**ADDENDUM 2****Addendum #** 2**Date Issued** January 27, 2026**Project Name | Job #** White Earth Withdrawal Management Facility | 20237410**Bid Date | Time** Tuesday, February 3, 2026 | 3:00 pm

THIS ADDENDUM AMENDS AND BECOMES PART OF THE CONTRACT DOCUMENTS FOR EAPC PROJECT 20245580 DATED 12/5/2025, RESPECTIVELY. EACH BIDDER SHALL ACKNOWLEDGE RECEIPT OF THIS ADDENDUM BY MARKING THE ADDENDUM NUMBER AND DATE ON THE BID FORM.

DRAWING TITLE
**FIRST FLOOR
VENTILATION PLAN**
M301

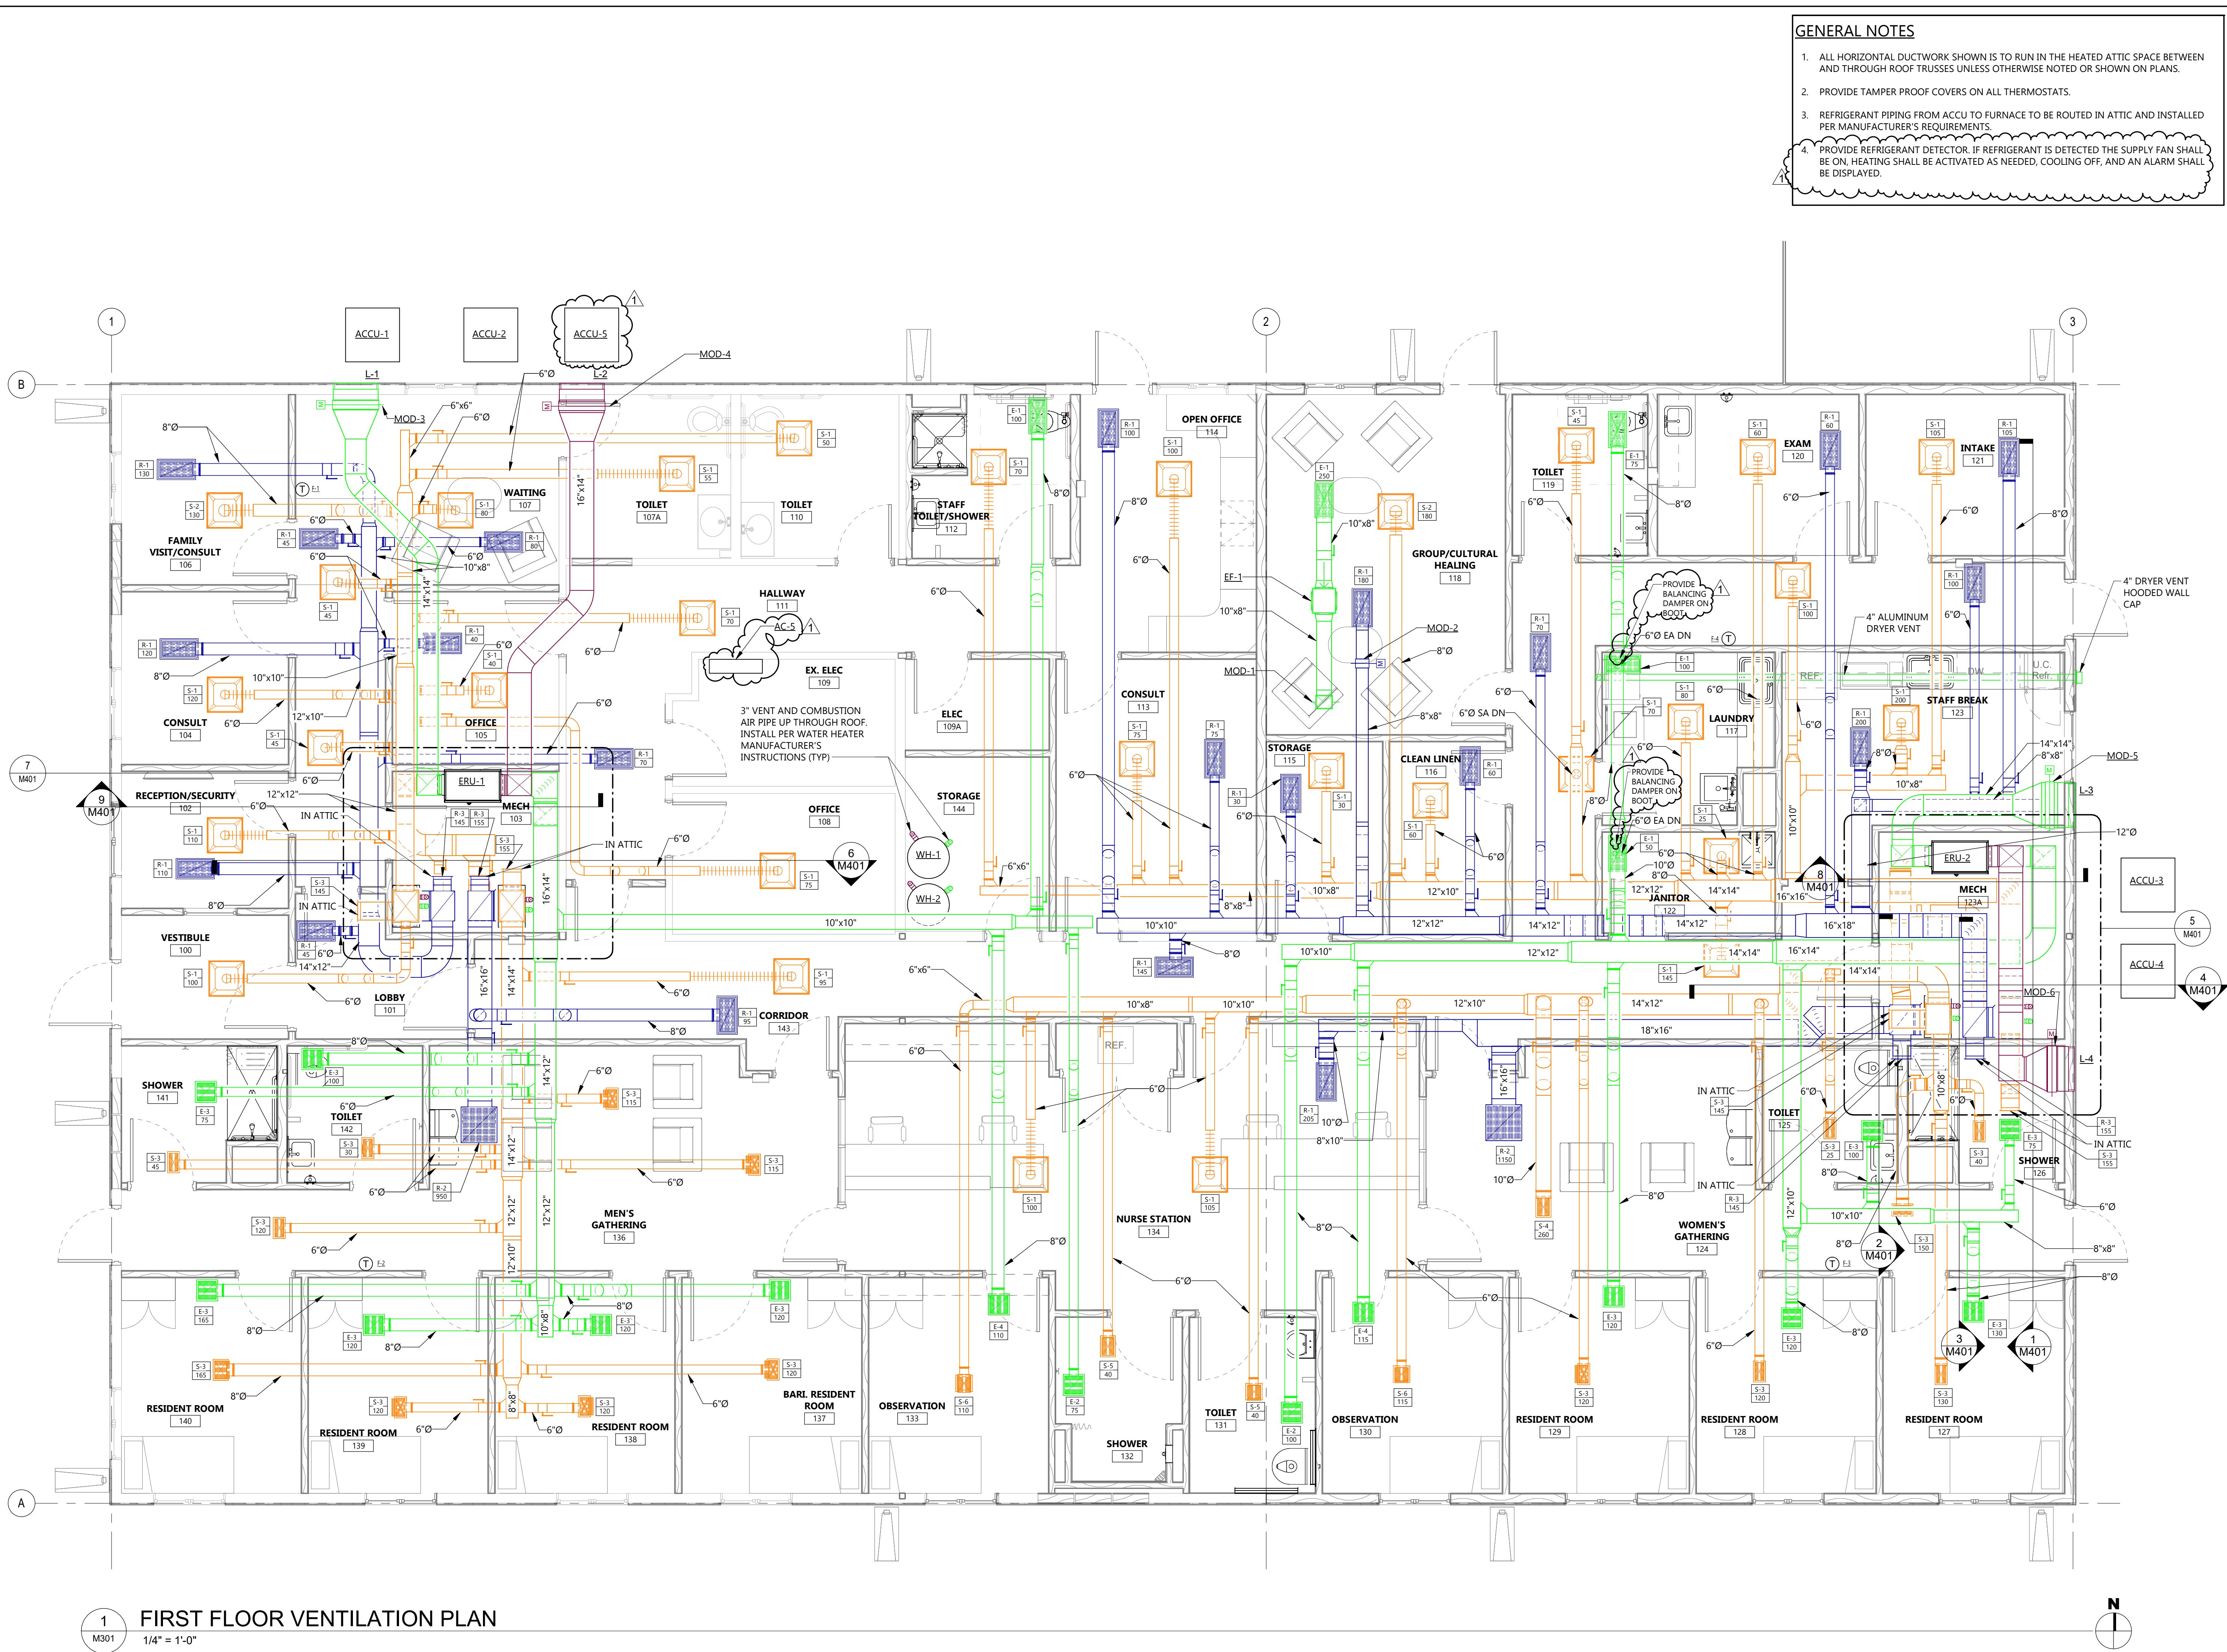
M301 Added mini split air conditioner, added balancing damper note, added furnace refrigerant detector.

DRAWING TITLE
FIRST FLOOR
DEMOLITION PLAN

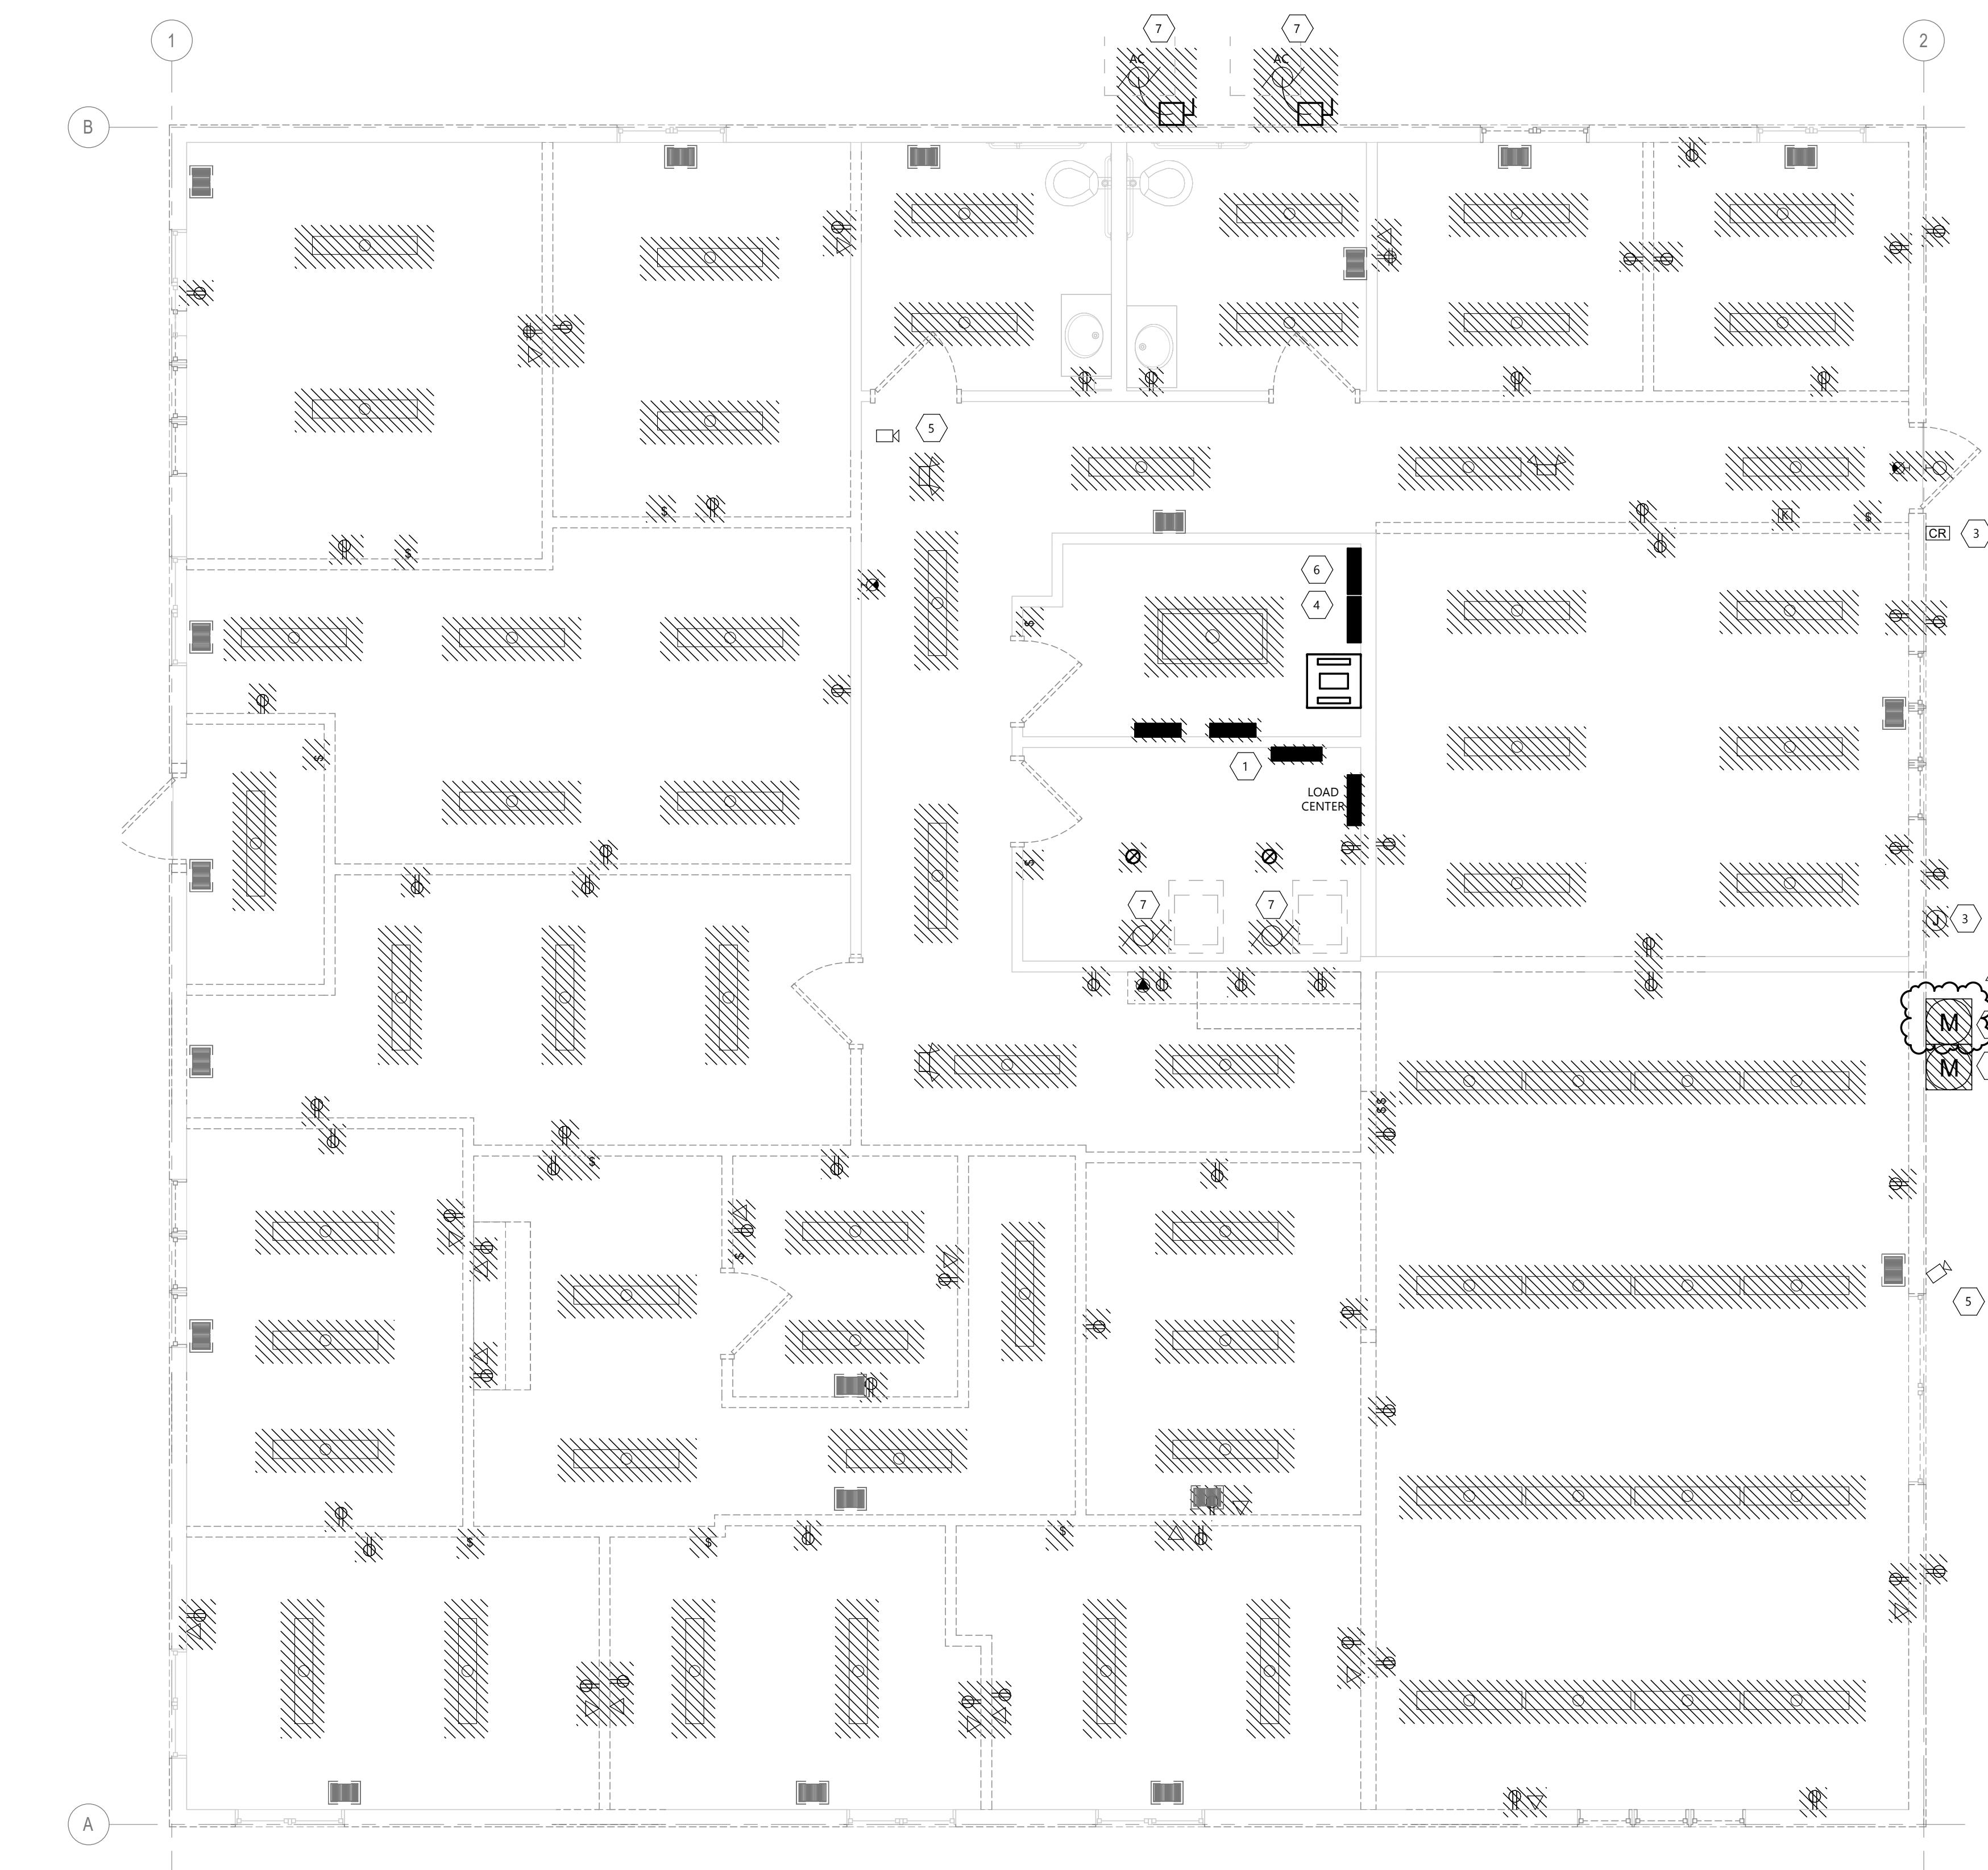
E102 REVISED Keynote 2.

REVISED Meter demolition on drawing to show both meters being demolished.

FIRST FLOOR POWER PLAN
E201
1/8" = 1'-0"

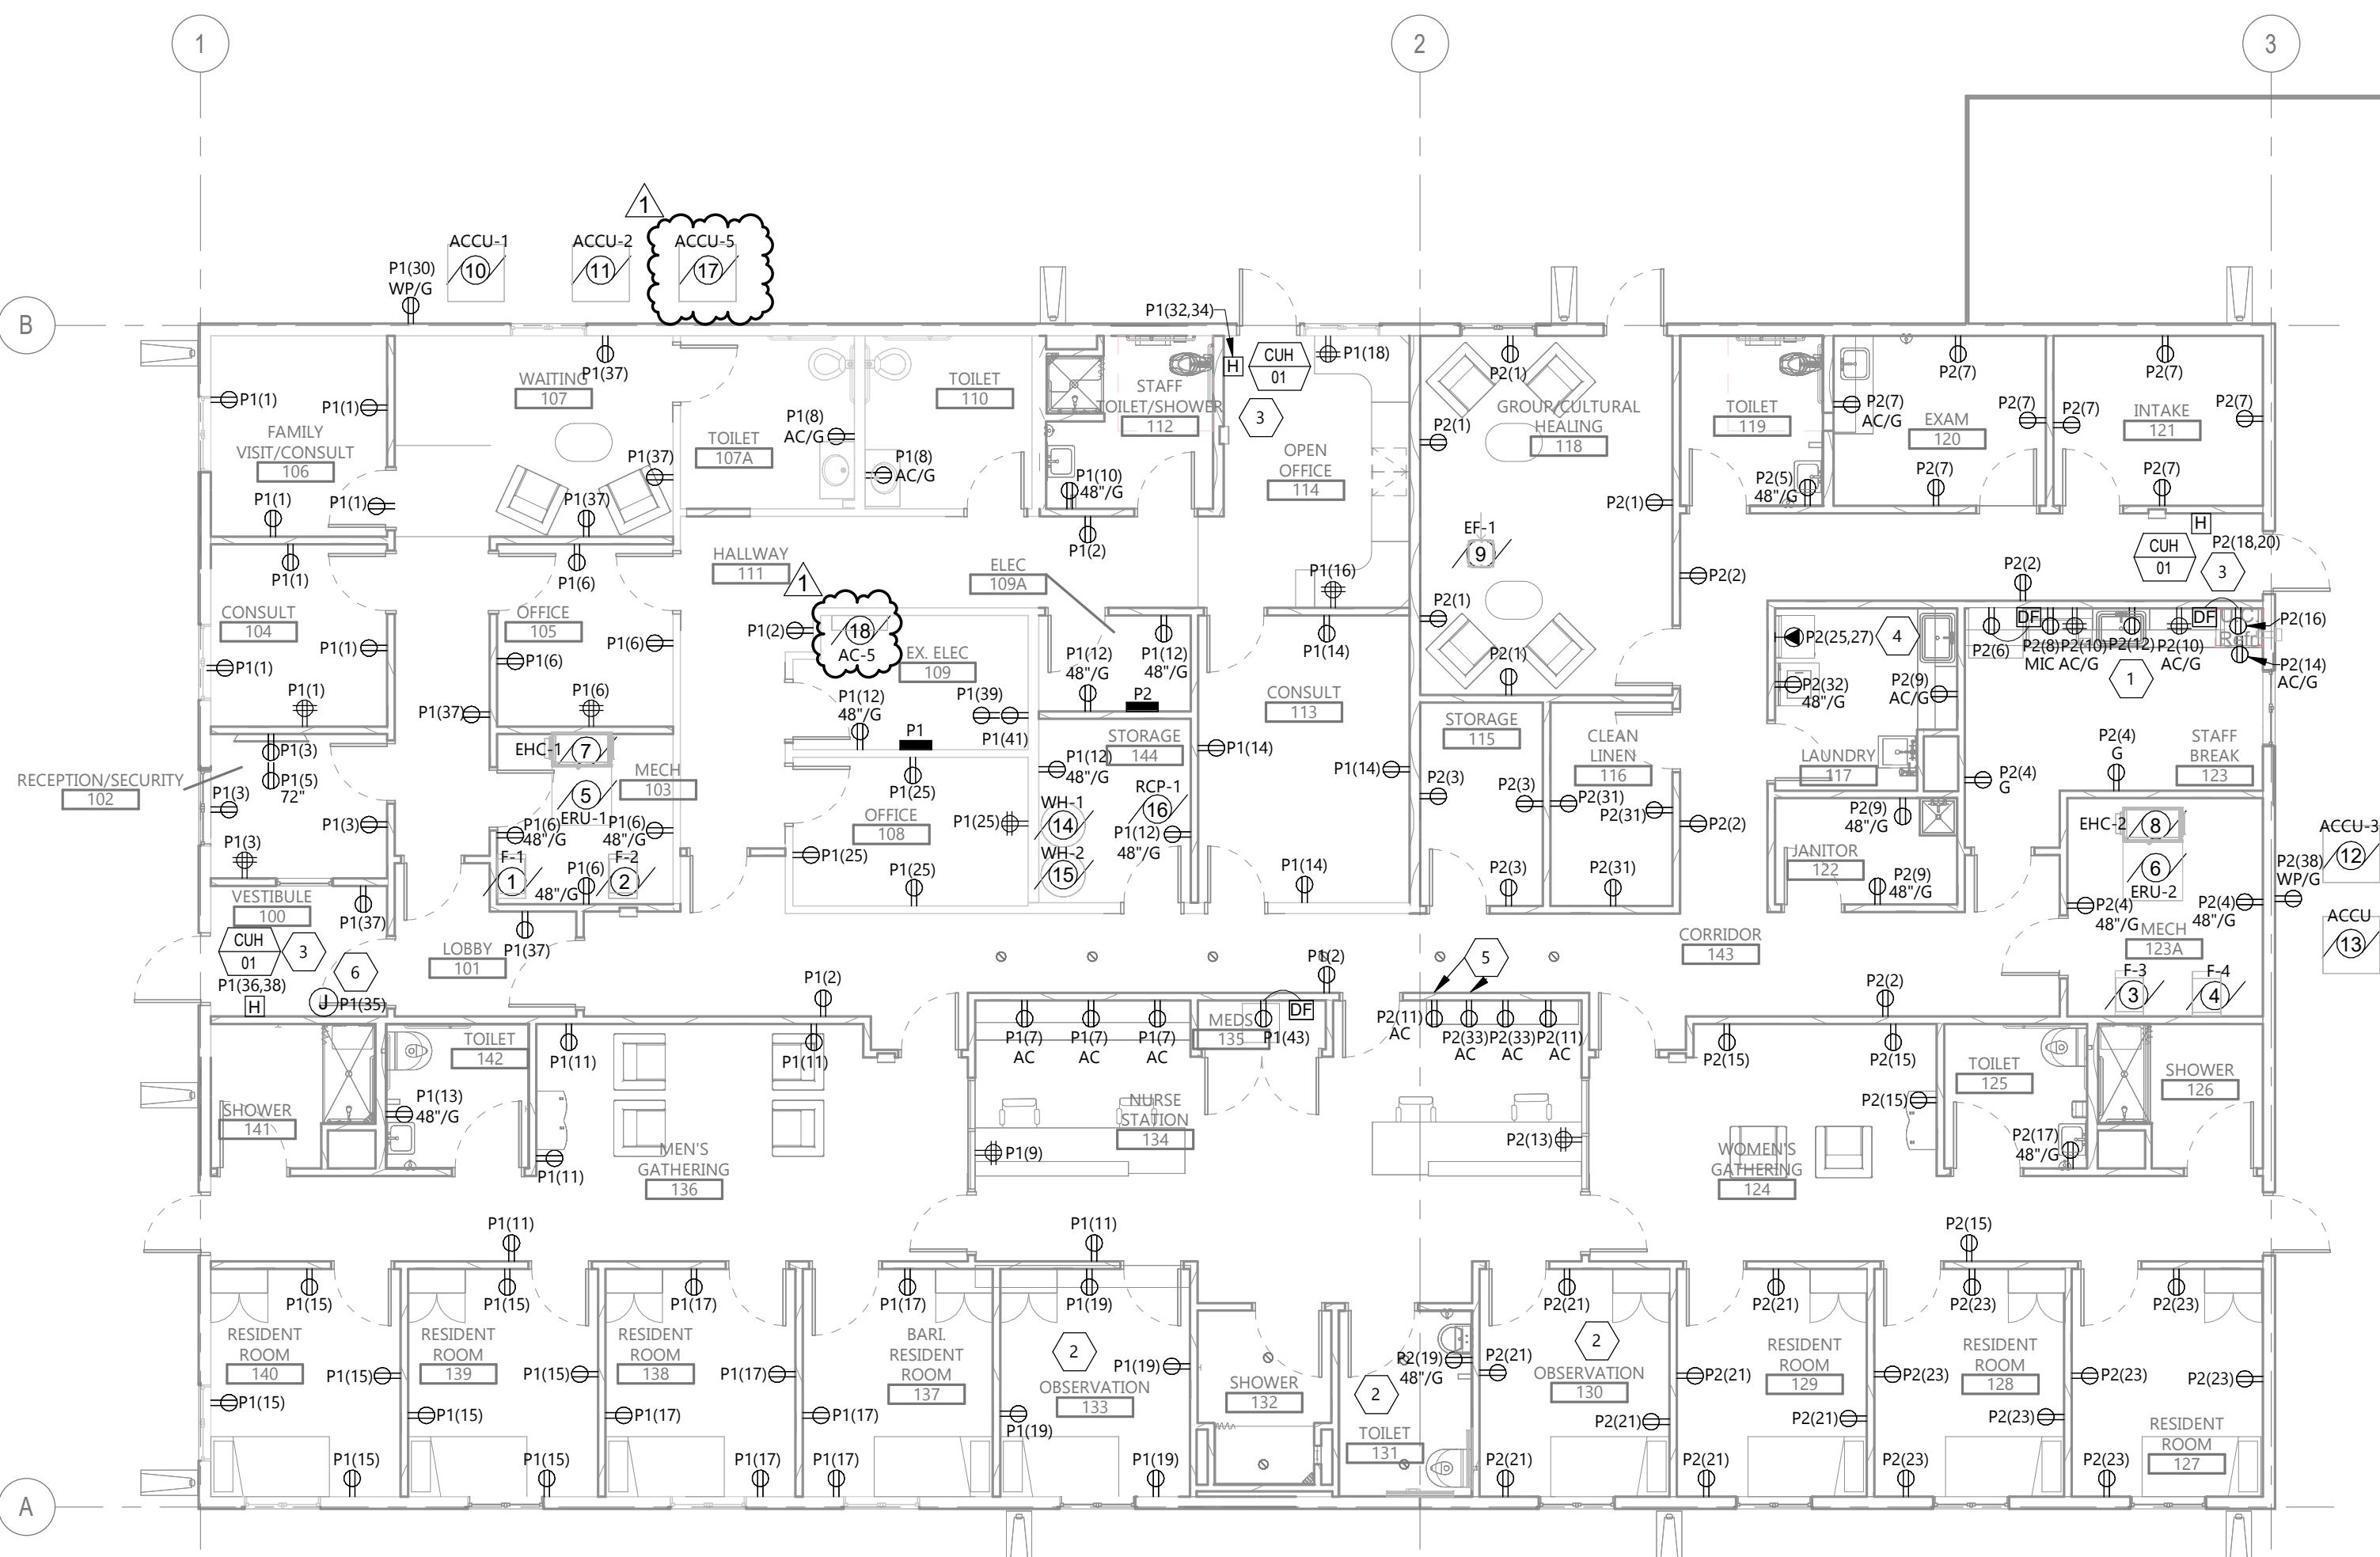
E201 ADDED ACCU-5 to exterior of building.

ADDED AC-5 to Ex. Elec Room 109.
